Record of Executive Business and Chief Executive's Order

Reg. Reference: SD22A/0352 **Application Date:** 08-Sep-2022
Submission Type: New Application **Registration Date:** 08-Sep-2022

Proposed Development: Construction of two new three storey primary school buildings for Gaelscoil na Camoige agus Gaelscoil Chluain Dolcain providing 16 classrooms each, a shared general purpose area, ancillary teaching and staff accommodation; The development will also consist of the construction of a new single storey PE Hall building for Colaiste Chillian; The development will also include two new pedestrian access routes, with one located on New Nangor Road and with another located at the junction of New Nangor Road and Old Nangor Road; A new vehicle entrance and exit onto Old Nangor Road to provide a one-way vehicle route with a bus/vehicle set down zone, conversion of existing vehicle entrance to Colaiste Chillian to an in-only entrance; 2 new hard play courts and play space at each primary school with site landscaping, bicycle parking spaces and car parking spaces for each primary school including accessible car parking spaces, internal refurbishment works to Colaiste Chillian to facilitate

Description:

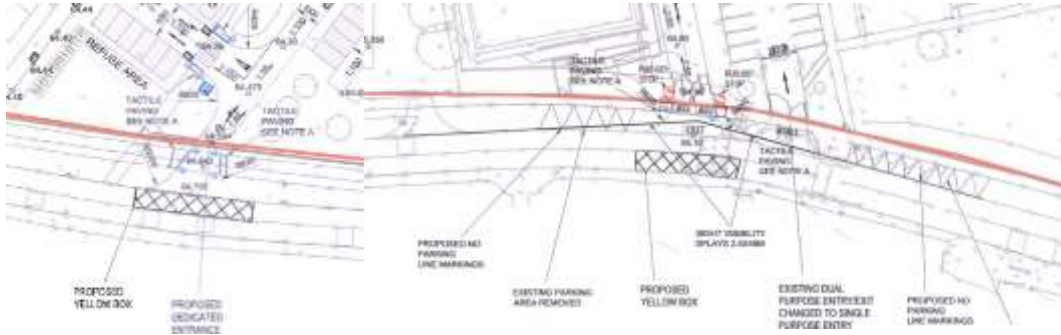
*The vehicle entrance to the west side of the Old Nangor Rd is satisfactory to the Roads Department. **A raised table to be incorporated into the entrance design – AI.** Roads have issue with the proposed layout on the east side. One dual access/egress will be satisfactory to Roads Department instead of the two proposed. Reason: Pedestrian safety. **A revised drawing to be submitted with amended layout showing one access/egress point instead of two.***

- 1. Applicant to provide a Transport and Traffic Assessment.*
- 2. Applicant to provide a Stage 1 & 2 Road Safety Audit.*
- 3. Applicant to provide a revised drawing which shows raised tables at both proposed new entrance/egress points.*
- 4. A revised drawing to be submitted showing one access/egress point instead of two on the east side of the Old Nangor Road.*
- 5. Applicant to provide further detail regarding the new pedestrian access point (i.e., type, opening width, mobility friendliness).*
- 6. Roads Department require a clearer car-parking rationale, and one that is in line with the maximum parking rates as per the CDP 2022-28.*
- 7. A TIC drawing to be provided showing any locations that will be offered for TIC to SDCC.*
